Access Compliance Report

Public Rights-of-Way

Intersection ID: 30490	Main Street: BRAMWYCK_DR	Cross Street: QUAIL_PARK_DR	Location: NW
ADA ID: FA5D7DA012FC	Ramp Type: PerpDiag	Initial Pass/Fail: Fail	Overall Compliance: No
Severity Score: 10			
Codes/Mitigation Info/Possible Solution		Field Measurements/Component Compliance

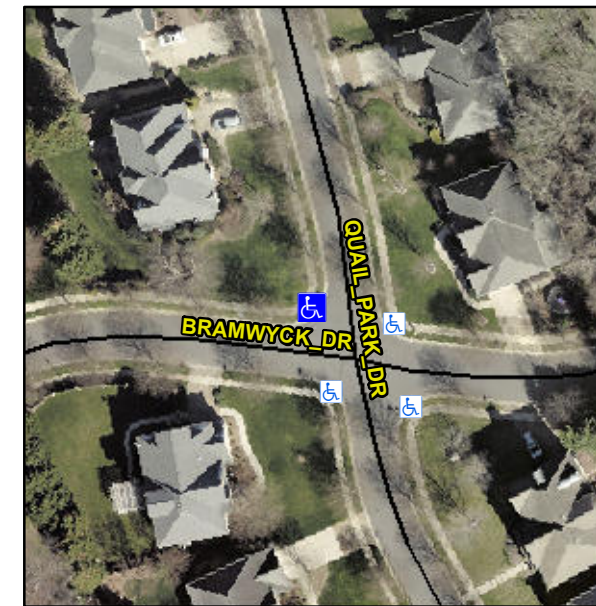
Remove & Replace Curb Ramp With Two New Directional Ramps or Equivalent.

R304.5.1, R304.5.3

Compliance	Description	Data	Compliance	Description	Data
N/A	Ramp Length (in)	49.0	Yes	Ramp Slope (%)	5.6
No	Ramp Width (in)	39.0	No	Ramp XSlope (%)	2.5
N/A	Flare Type LT	N/A	N/A	Flare Type RT	N/A
N/A	Flare Slope LT (%)	N/A	N/A	Flare Slope RT (%)	N/A
N/A	Flare Traversable LT?	N/A	N/A	Flare Traversable RT?	N/A
N/A	Landing Length (in)	N/A	N/A	DWS Provided?	N/A
N/A	Landing Width (in)	N/A	N/A	DWS Contrast?	N/A
N/A	Landing Slope (%)	N/A	N/A	DWS Length (in)	N/A
N/A	Landing X Slope (%)	N/A	N/A	DWS Full Width?	N/A
N/A	Landing Curb? (Y/N)	N/A	N/A	DWS Offset (in)	N/A
N/A	Shared Landing?	N/A			
N/A	Gutter Ponding?	N/A	N/A	Gutter Slope (%)	N/A
N/A	Gutter Lip Ht (in)	N/A	N/A	Gutter X Slope (%)	N/A
N/A	Painted X Walk1?	No	N/A	Painted X Walk2?	No
	X Walk 1 Direction	To S		X Walk 2 Direction	To SE
N/A	X Walk 1 Width (in)	N/A	N/A	X Walk 2 Width (in)	N/A
	X Walk 1 Slope (%)	4.8		X Walk 2 Slope (%)	2.4
	X Walk 1 X Slope (%)	3.0		X Walk 2 X Slope (%)	2.4
